Response to Submissions and Preferred Project Report
Part 3A – Concept Plan Application – MP10_110
Residential Flat Development

74-76 Belmore Street, Ryde
(Also known as 8 Junction Street)

Prepared for: Achieve Australia
Project No: 7666A
Date: May 2012

Figure 1: North east elevation of approved 2-4 Porter Street

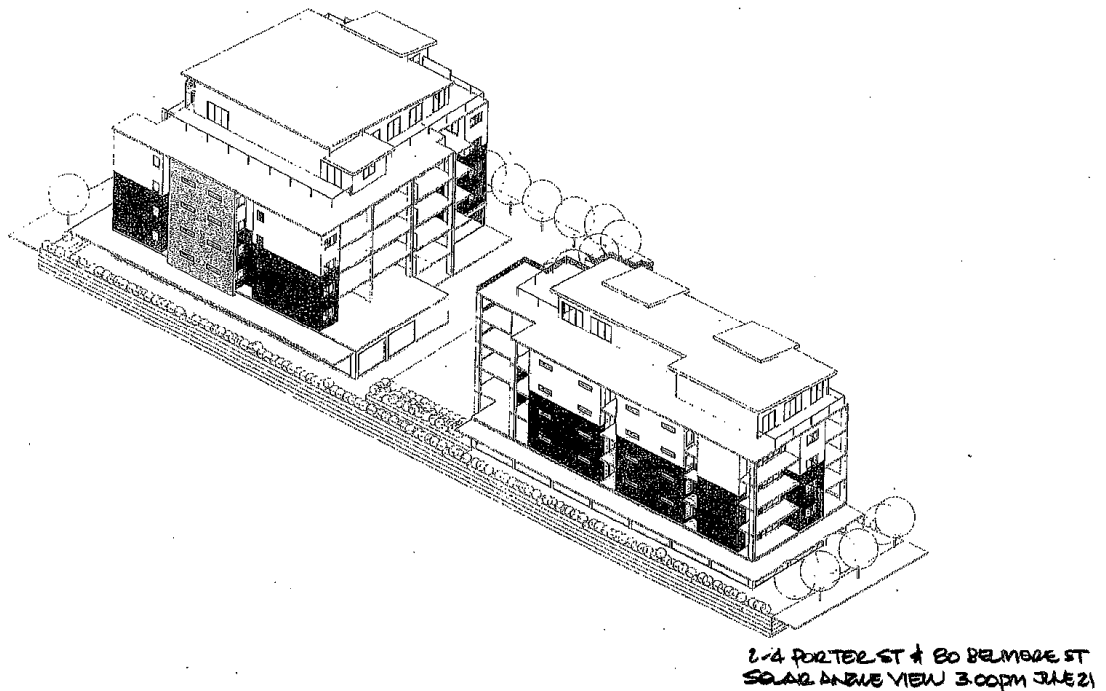
In order to consider this issue the approved design of 2-4 Porter Street (including 80 Belmore Street) needs to be examined and understood.

The proposal to construct buildings on the adjacent site at 80 Belmore Street and 2-4 Porter Street was firstly evaluated by examining the drawings issued by Ryde Council during the public advertising period. The development has since been approved. Figure 1 below is a 3D view illustrating the north east elevation of the building on 2-4 Porter Street which adjoins the interface with the subject site.

- The building has a 5m front setback to both Porter Street and Belmore Street (i.e. similar to the front setbacks proposed in the Concept Plan).
- The residential levels are setback 4m (western building) and 6m (eastern building) from the common boundary and the upper level is setback 6.5m (western building) and 11m (eastern building).

- The north east wall of the proposal is planned to be parallel to the adjoining boundary.
- The lowest (ground floor) level of the approved development on 2-4 Porter Street comprises commercial or retail tenancies and a colonnade walkway. The more sensitive residential uses that the RFDC relates to commence at first floor level and above. There are however two ground floor dwellings facing the development's internal courtyard.

- The north east facade is generally not relied upon to provide solar access to the habitable rooms and balconies of the development. Instead solar access is achieved using the south east and north west facades.

- No large or full height windows occur in the north east façade for the use of outlook. There are windows indicated that are high level horizontal slit windows only above eye level and will not view directly into any proposed development on 76 Belmore Street. These are evident in Figure 1 and notated on the floor plans in Figures 2 and 3.

- In the centre of the wall there are recesses (800-1000mm) deep set in the walls and windows recessed (1000mm) behind projecting blades in the outer wall which conceal the windows to the boundary. These are evident in Figure 1 and on the floor plans in Figures 2 and 3. The blade walls and screening to these spaces limits solar access and they are effectively self-shaded until about midday at the winter solstice. The shadow diagrams prepared for the proposed building envelopes demonstrate that these recesses are unaffected after 12noon at the winter solstice.

The building envelope to Block A has been revised to provide a 12m setback from the common boundary with 2-4 Porter Street for the majority of the envelope. This will ensure an acceptable solar access outcome for 2-4 Porter Street. The envelope to Block E has not been identified as requiring any amendment to achieve solar access objectives. The building envelopes as proposed satisfactorily respond to the building separation requirements, solar access and privacy considerations of the RFDC.
